Technical Bulletin

PowerGrip® Kit K015563XS

GATES REFERENCE :	PowerGrip Kit K015563XS
MAKE :	OPEL / VAUXHALL
MODEL :	Astra, Combo, Corsa, Meriva
MOTOR :	1.7 Di / DTi (ISUZU) / CDTi
MOTOR CODE :	Y17DT, Y17DTL, Z17DTH

Installation recommendations for timing system on GM/Isuzu engines Y17DT, Y17DTL and Z17DTH using K015563XS

Fig. 1a
OE ref. 5636724

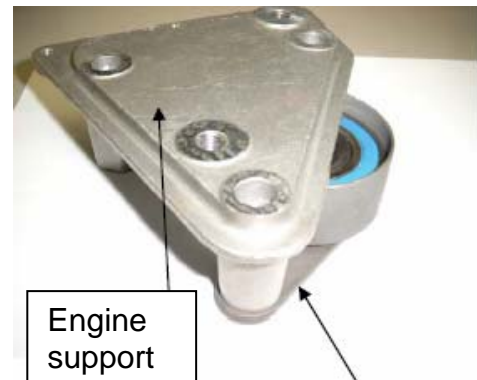
The coil spring tensioner is also used as an upgrade of the old tensioner (OE ref. 5636724 – fig.1a) which is no longer available at OES level. For these engines (until engine number 328704), however, there is a problem to install the new tensioner along with the existing engine support bracket. Fig.1b shows how the base plate of the old tensioner is placed under the bottom leg of the engine support bracket. The new tensioner does not have such a base plate.

To replace an old type tensiometer with the new coil spring one, one needs to replace the engine support bracket as the bottom leg now has to be just as long as the other two. Additionally, a stud (OE ref. 5636706 - Fig.2 b) has to be inserted to attach the coil spring of the new tensiometer.

So we need to adjust the components of our kit to also cover the older vehicles. But as the new support bracket (OE ref. 5684110) is quite expensive, we have decided to offer one efficient low cost replacement solution for all engines.

We will do this by including a high grade stainless steel spacer (Fig. 3), with the same thickness as the base plate of the original tensioner, to overcome the length difference in the legs of the engine bracket.

We will therefore cancel our kit K015563XS and introduce a new one: K025563XS.

- the belt 5563XS – OE ref. 636227
- the coil spring tensioner – OE ref. 5636739
- the tensioner bolt (M10) – OE ref. 5636713
- the stud – OE ref. 5636706
- the spacer (Fig.3) (same thickness as the base plate of the old tensioner)
- the idler - OE ref. 636730
- the idler bolt (M12)

Fig.4

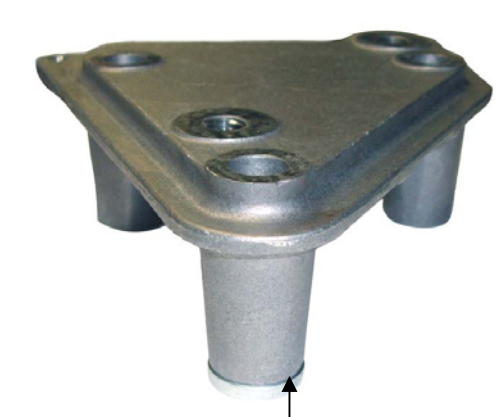
- 1) remove old tensioner, spring, idler and belt
- 2) install new idler and bolt
- 3) insert and tighten (18,6 Nm) stud at the right side of the injection pump pulley (Fig. 4)
